| marantz® SERVICE BULLETIN | | Date: 28-Aug-2004 | Model: SR5400, SR6400 |
| | | Page: 1 / 2 | REF.NBR: MZ04-061 |
| | | Subject: 1. Noise from Surround L/R Speaker. 2. The Sound is MUTE by operation of HDD Recorder. 3. The output level changes. | |

DSP PCB

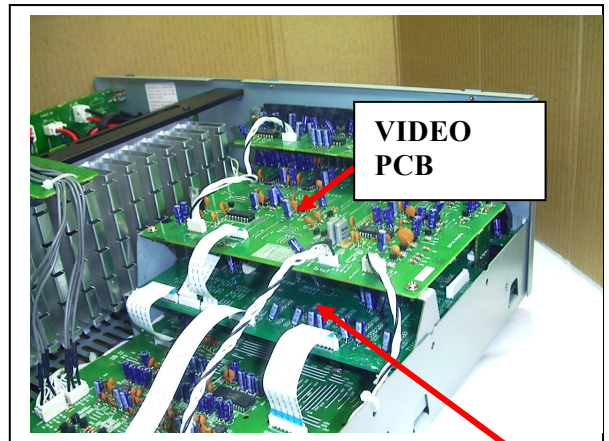
1. Replace the microprocessor **IC28** on the **DSP PCB**. Version to [**V040412 1**]
2. Replace the DSP **IC20** on the **DSP PCB**. DSP Code ID to [**CD02 02010116**]
Please see to the service manual page 60 about details of "10. SERVICE MODE".

- 1. POS. No. IC28** **Part no. 90M-HS27AWH2R** **(HVIHD64F2398F20 programmed flash ROM)**
[OLD part no. * HS27AWH0R]
- 2. POS. No. IC20** **Part no. 90M-HS27AWX2R** **(HVIMX29LV400TTC programmed flash ROM)**
[OLD part no. * HS27AWX0R]
